SUBJECT PROJECT CONCEPT REPORT APPROVAL

SUBJECT PROJECT CONCEPT REPORT

SUBJECT: CONCEPT REPORT

SUBJECT **Proposed Project Concept Report**

NH - 006-2(56)
P.L. 422660
DOUGHERTY COUNTY
S.R. 3/ LIBERTY PKWY.
CLARK AVE. .
2005 PM DHV * (000)
2005 AM DHV * 000

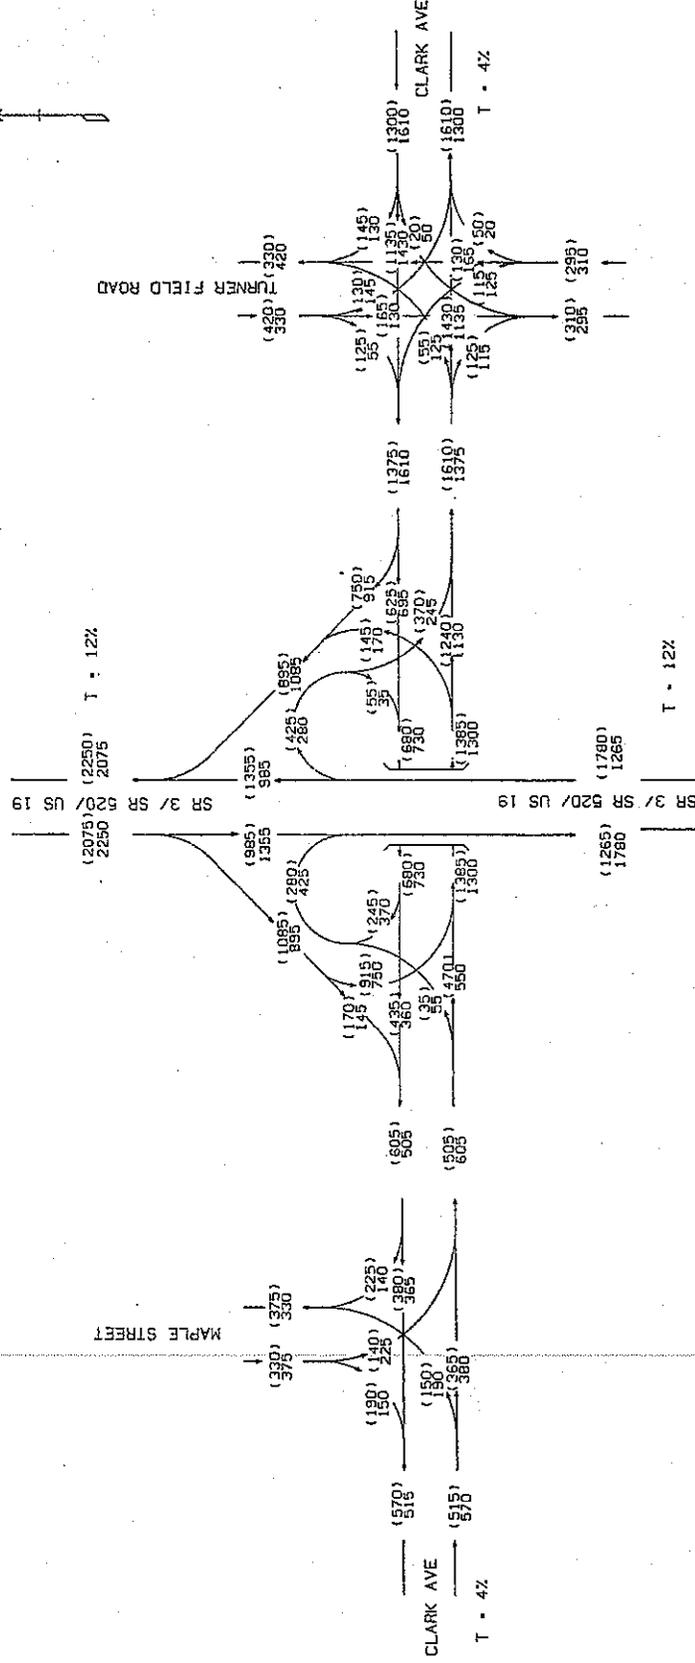
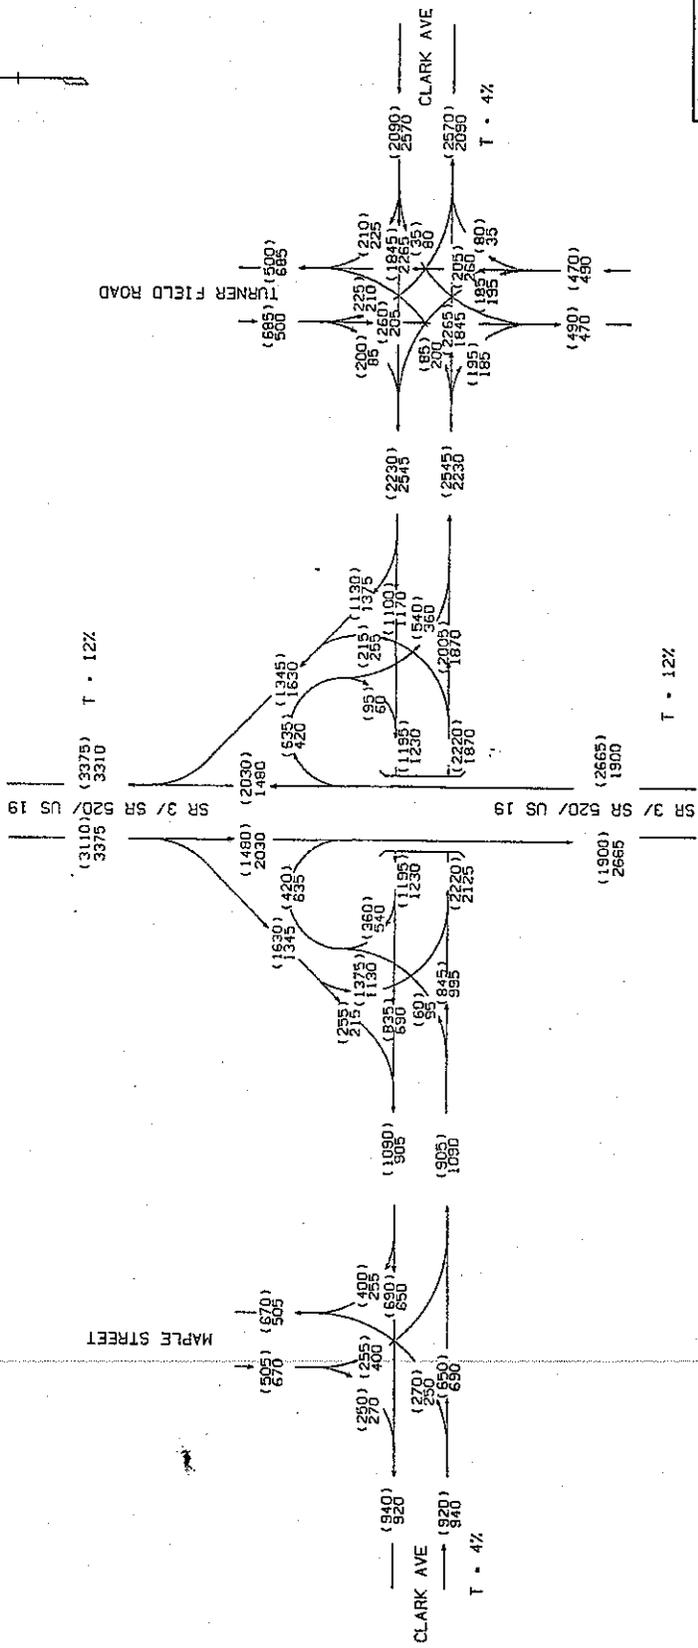
SEE
COLLECTED
TRAFFIC DATA
ON PAGE 13
JHP

1. Clark Avenue traffic should be presented as the total for both directions of travel. Average Daily Traffic (ADT) is usually presented in this manner.
2. Traffic for Clark Avenue is not consistent throughout the report. Page 2 shows year 2025 traffic as 35,905 vpd, the Need and Purpose Statement shows year 2025 traffic as 39,000 vpd, and the cost estimate shows year 2025 vpd as 11,535 vpd.
3. Accident information is presented on Page 3 for northbound ramps and in the Need and Purpose Statement for the southbound exit ramp. The presentation is difficult to follow and appears to be inconsistent. Also, the collision diagram referenced on Page 2 was not included in the report.
